**NSLPP MEETING HELD ON 04/12/2024**
SECTION 4.55 APPLICATION REPORT**Attachments:**

ADDRESS/WARD: 9 Undercliff Street, Neutral Bay**APPLICATION NO:** DA 430/21/3**PROPOSAL:** Section 4.55(2) modifications to DA 430/21 for various changes to an approved apartment development**PLANS REF:**

OWNER: QH A1 Pty Ltd**APPLICANT:** QH A1 Pty Ltd c/o Corben Architects**AUTHOR:** Robin Tse, Senior Assessment Officer**DATE OF REPORT:** 22 November 2024**DATE LODGED:** 15 August 2024**RECOMMENDATION:** Approval

Figures 1 – 4: Proposed Modifications

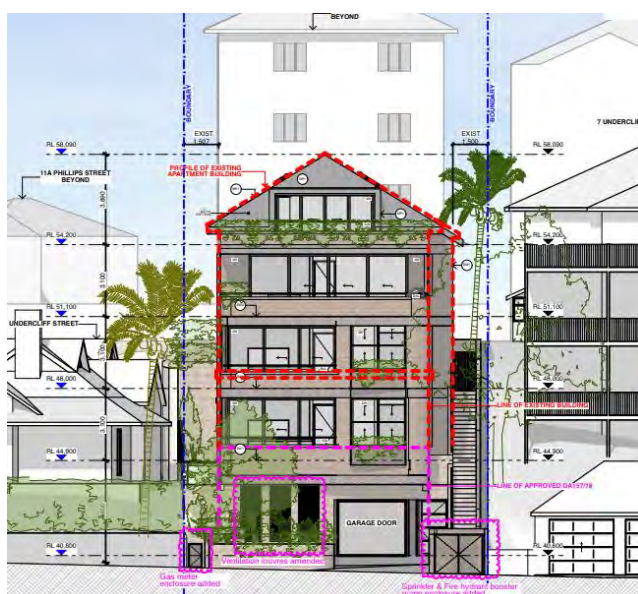
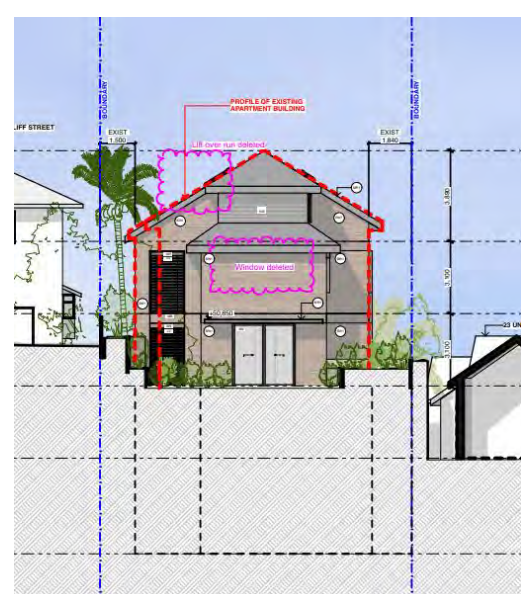
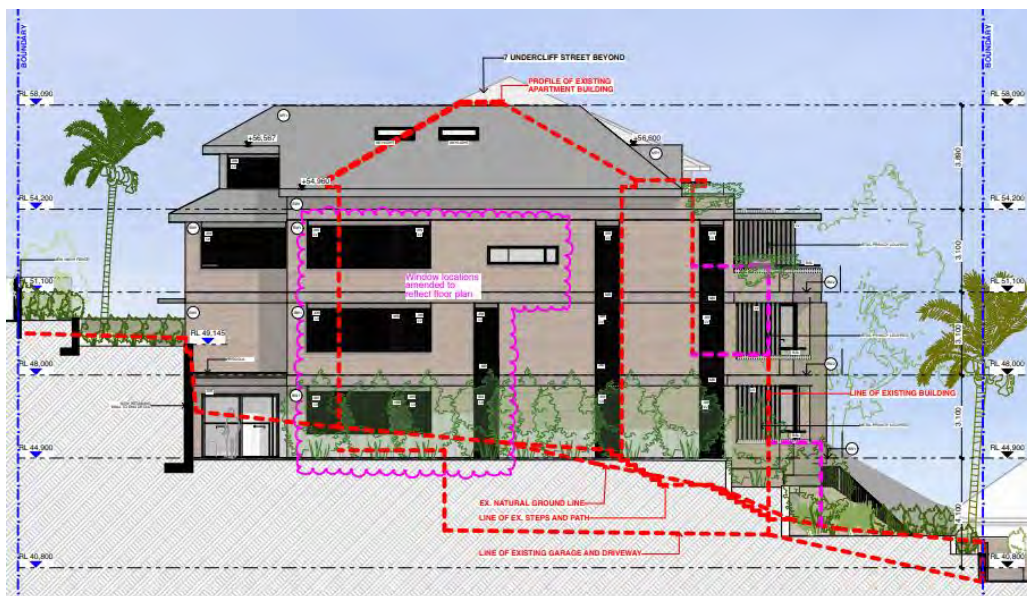
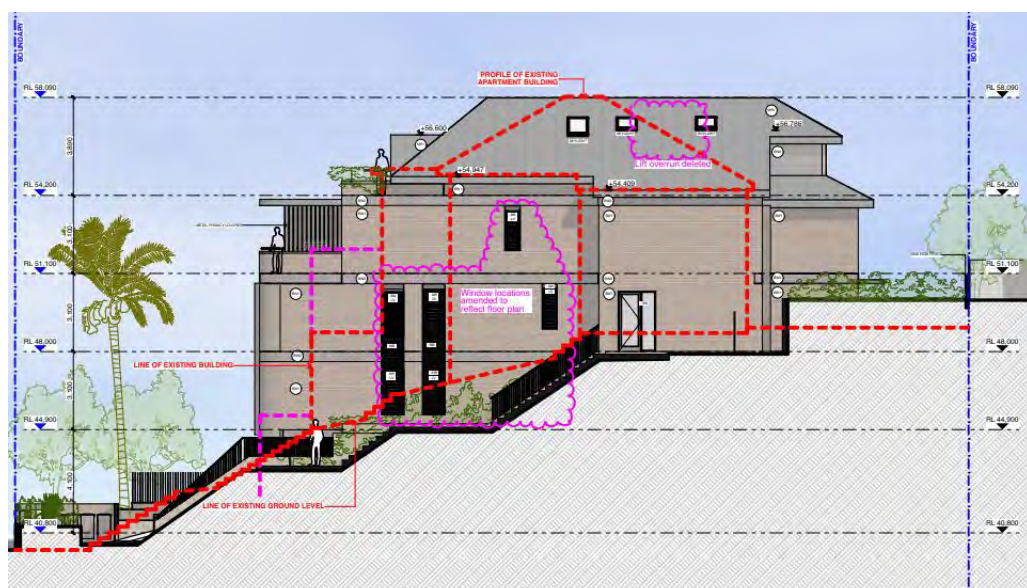
- Relocation of entry door to Unit 3 to comply with the relevant NCC requirements;
- Internal layout changes including removal of the family room (to be replaced by Bedroom 3), enlargement of Bedroom 2, provide ensuite for Bedrooms 2 and 3 and changes to the layout of bedroom 1, its ensuite and robe, pantry laundry and WC; and
- Fenestration changes associated with the internal layout changes including:
 - North-west (side) Elevation:
 - Replacement of a sliding door and a bedroom window with a window for Bedroom 2 and an ensuite window.
 - South-east (side) Elevation:
 - Relocation of the ensuite window and laundry windows.

- Relocation of entry door to Unit 2 to comply with the relevant NCC requirements;
- Internal layout changes including removal of the family room (to be replaced by Bedroom 3), enlarge Bedroom 2, provide ensuite for Bedrooms 2 and 3 and changes to the layout of bedroom 1, its ensuite and robe, pantry laundry and WC and
- Fenestration changes associated with the internal layout changes including
 - North-west (side) Elevation:
 - Reconfiguration of Bedroom 2 window; and

- Relocation of entry door to Unit 1 to comply with the relevant NCC requirements;
- Internal layout changes including removal of the family room (to be replaced by Bedroom 4), enlarge Bedroom 3, provide ensuite for Bedrooms 3 and 4;
- Fenestration changes associated with the internal layout changes including in the relocation of the window to Bedroom 3 and the window to its ensuite and changes to windows including deletion of windows to the lobby and Bedroom 4

Figure 13: Retaining wall and floor plan (as per Condition C39)

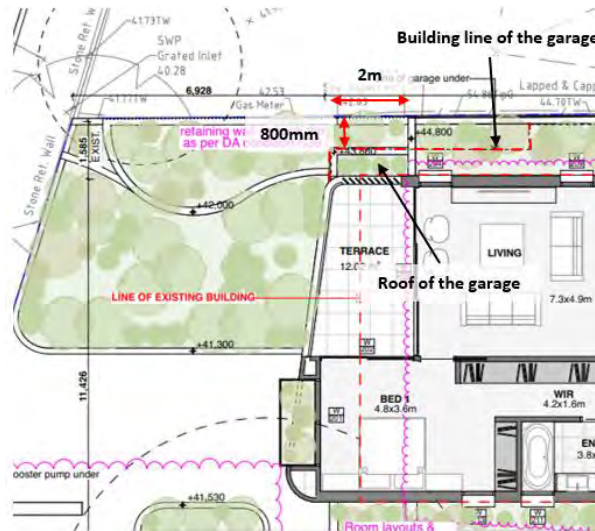
The intent of Condition C39 requiring additional setback of the retaining wall is to “reduce the bulk from the street and provide a more appropriate juxtaposition with the adjoining heritage item.” The design amendments would also result in an area for soft landscaping at RL41.975 between the approved apartment building and the property boundary of the adjoining heritage item at No.23 Undercliff Street.

However, the footprint of the approved garage would restrict the size of the area available for soft landscaping at RL41.975 with a maximum width of 800mm between the outer wall of the garage structure and the common property boundary with No. 23 Undercliff Street (**Figure 13**). There would be some scope for soft landscaping on the roof of the garage structure.

Whilst some soft landscaping can be provided within the 800mm wide planting area, this restricted space is unlikely to provide ideal growing conditions for substantial soft landscaping as the condition originally intended due to the narrow width and the shading from the retaining wall along the north-western (side) property boundary. Furthermore, the effectiveness of softening of the building bulk and the impacts on the streetscape are contingent on the provision of substantial soft landscaping to screen the retaining walls and any other building elements that are in close proximity to the property boundary of No.23 Undercliff Street.

Figure 14: Retaining wall and floor plan (Applicant's proposal)

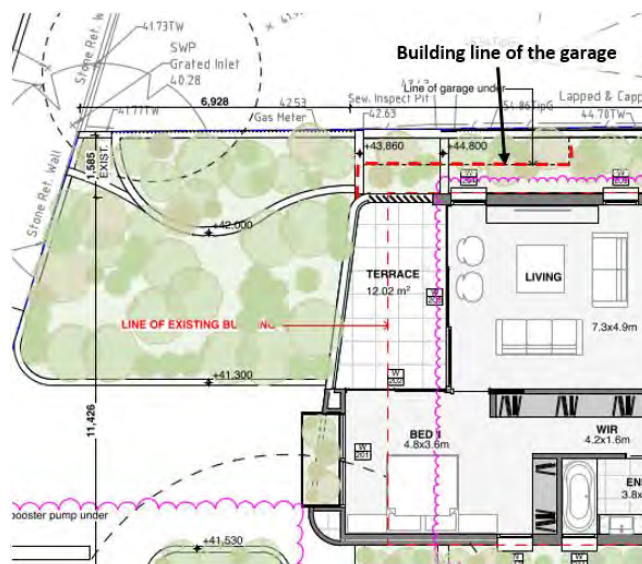
The applicant has proposed a stepped terrace within the side (north-western) building setback area with the first terrace at RL43.86 and the top terrace at RL44.80 as shown in **Figures 12 and 14**. Whilst the current proposal is similar to the original DA design, it is considered that the design would provide sufficient landscaping to provide a landscape buffer to soften the built form of the subject development and the heritage item at No.23 Undercliff Street. In particular, the applicant has submitted a landscaped plan showing the planting of 26 x Lilly pilly (*Acmena smithii* ‘Sublime’) with a mature height of 5m along the north-western property boundary and a landscaped front garden adjacent to No.23 Undercliff Street with substantial planting including 2 x Coastal Banksia (*Banksia integrifolia*) with a mature height of 9m and 1 x Bracelet honey myrtle (*Melaleuca armillaris*) with a mature height of 8m (**Figure 15**). In addition, soft landscaping is also proposed on the stepped terrace along the side (north-western) building setback (**Figure 16**).

It is therefore considered that the applicant's submission, supported by architectural and landscape plans, should achieve an outcome that is generally consistent with the intent of the design amendments as required by Condition C39 and no objection is raised to the proposed deletion of this condition.

Figure 15: Proposed landscaping within the front garden

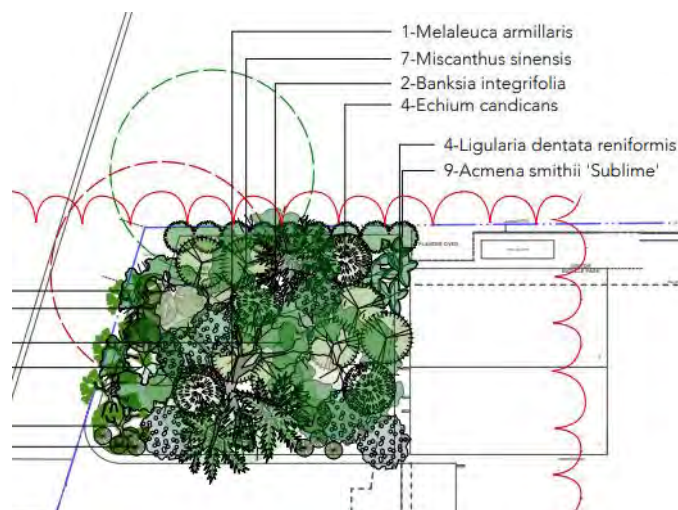
Furthermore, the stepped terrace would be screened by the planting within the front garden and along the side property boundary as seen from the street. Therefore, the impacts on the adjoining heritage item at No. 23 Undercliff Street would be minimised.

North-western boundary (No.23 Undercliff St)

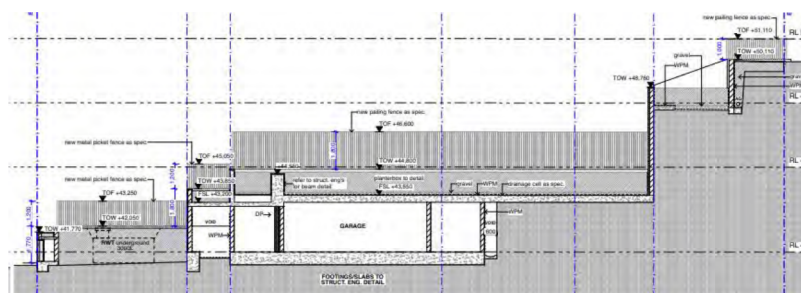
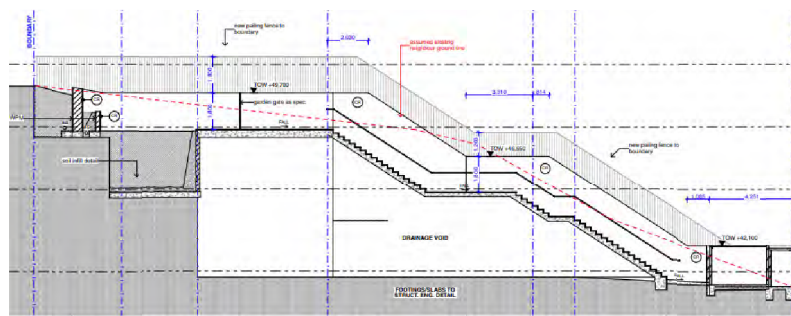
The applicant has provided indicative drawings showing a new rendered masonry wall topped with a timber wall along the side property boundaries with Nos 9 and 23 Undercliff Street. The applicant has also indicated the willingness to discuss the matter with the owners of the neighbouring properties on the design of boundary fencing.
